CAMPUS STANDARDS APPENDIX I

STANDARD PLASTER INSTALLATION AND DETAILS SEVERE WEATHER

Architect's Supplemental Instructions No. 035

Infill Apartment Repairs

TITLE: KRESGE - WINDOW SILL DETAIL	DATE: 01/17/14 SCALE:	DWG. NO:
	6" = 1'-0"	'
U.C. SANTA CRUZ INFILL APARTMENTS REPAIRS	REF. DWG: 1/AK9.01A	2.

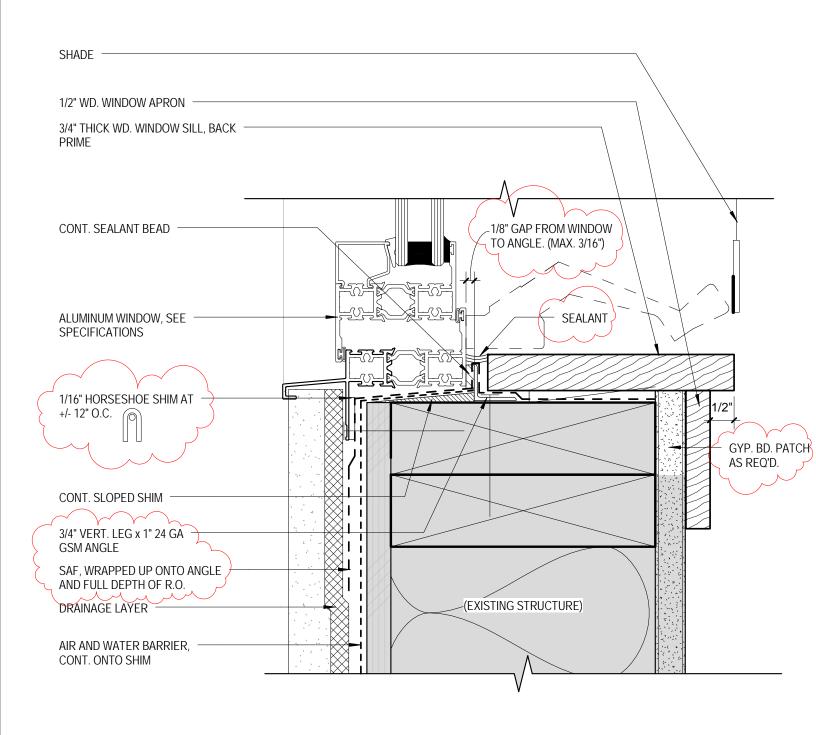
- 1. ASK 2.06R1 Kresge Window Sill Detail (1/AK9.01A)
- 2. ASK 2.07R2 Kresge Window Jam Detail (2/AK9.01A)
- 3. ASK 2.08R2 Kresge Window Head Detail (3/AK9.01A)
- 4. ASK 2.09R1 Stevenson Window Sill Detail (1/AS9.01A)
- 5. ASK 2.10R1 Stevenson Window Jam Detail (2/AS9.01A)
- 6. ASK 2.11R1 Stevenson Window Head Detail (3/AS9.01A)
- 7. ASK 2.13R1 Louver Sill Detail (1/AK9.02, 1/AS9.02)
- 8. ASK 2.14R1 Louver Jamb Detail (2/AK9.02, 2/AS9.02)
- 9. ASK 2.15R1 Louver Head Detail (3/AK9.02, 3/AS9.02)
- 10. ASK 2.16R1 Exterior Door Head (1/AK9.10A, 1/AS9.10A)
- 11. ASK 2.17R1 Exterior Door Jamb (2/AK9.10A, 2/AS9.10A)
- 12. ASK 2.18R1 Exterior Door Threshold at Landing (3/AK9.10A, 3/AS9.10A)

TITLE:	DATE: 01/27/14	
SCAFFOLDING BOLT WATERPROOFING DIAGRAM	SCALE: 3" = 1'-0"	
U.C. SANTA CRUZ INFILL APARTMENTS	ATTACHED TO:	
REPAIRS	REF. DWG: 10/AS8.01, 10/AK8.01

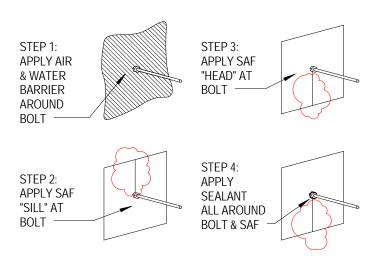
- 13. ASK 2.20R1 Scaffolding Bolt Waterproofing Diagram (10/AS8.01, 10/AS8.01)
- 14. ASK 2.21 GSM Door Pan Flashing (4/AS9.10, 4/AK9.10)
- 15. ASK 2.22 Enlarged Wall at Landing (10/AS8.21, 10/AK8.21)
- **16.** ASK 2.23 Enlarged Deck Edge Detail (9/AS8.21, 9/AK8.21) (**NOT REVISED, BUT INCLUDED AS PART OF MOCKUP MANUAL**)
- 17. ASK 2.24 Fabricated Penetration Flashing (12/AK8.01, 12/AS8.01)
